NL-04-0617

Joseph M. Farley Nuclear Plant Units 1 and 2
Application for License Renewal –
Requests for Additional Information

Responses to March 17, 2004 Requests for Additional Information

**UNIT 1 VERTICAL TENDONS
ACTUAL FORCE TREND PER TENDON BASIS
(from past 6 surveillances)**

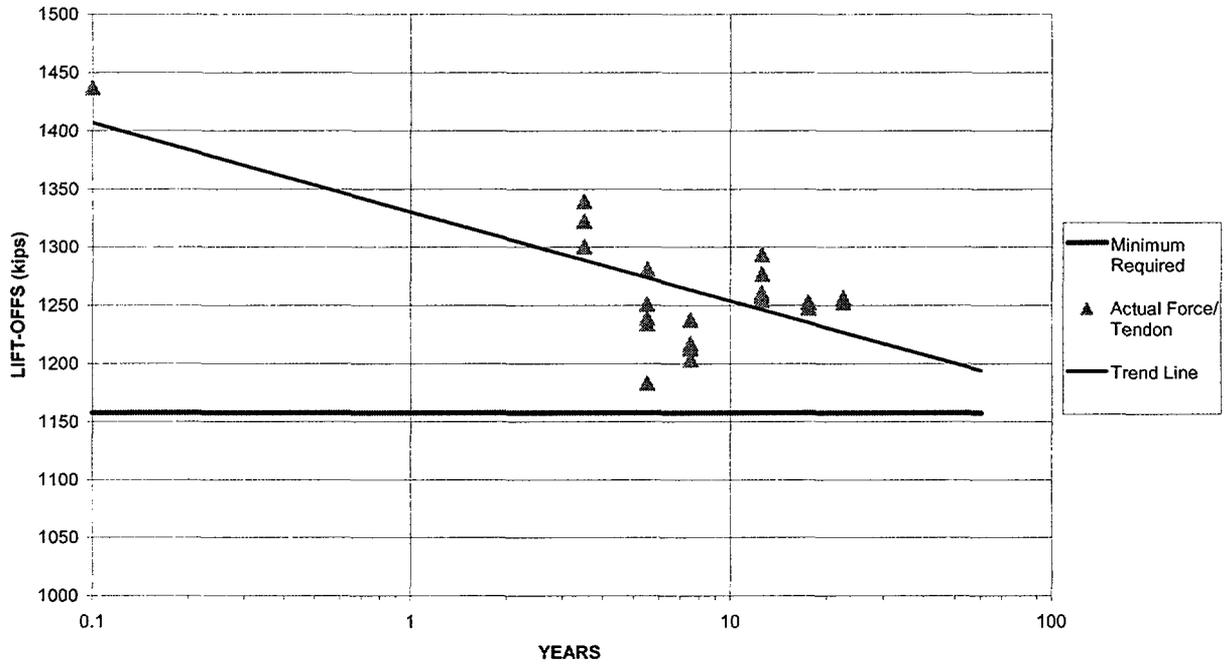
In RAI 4.3.4-1, the staff requested additional information on FNP's containment tendon analysis in order for the staff to make a reasonable assurance conclusion that the applicant demonstrates the adequacy of the analysis projected for the extended period of operation. SNC provided the requested information in RAI response letter NL-04-0318 dated March 5, 2004. In the response, the data for the tendons was provided on a "per wire" basis. In a March 15, 2004 telephone conference, the staff asked the applicant to present the prestressing forces on a per tendon basis.

- (a) The following are the minimum required prestressing forces per tendon (170 wires/tendon):
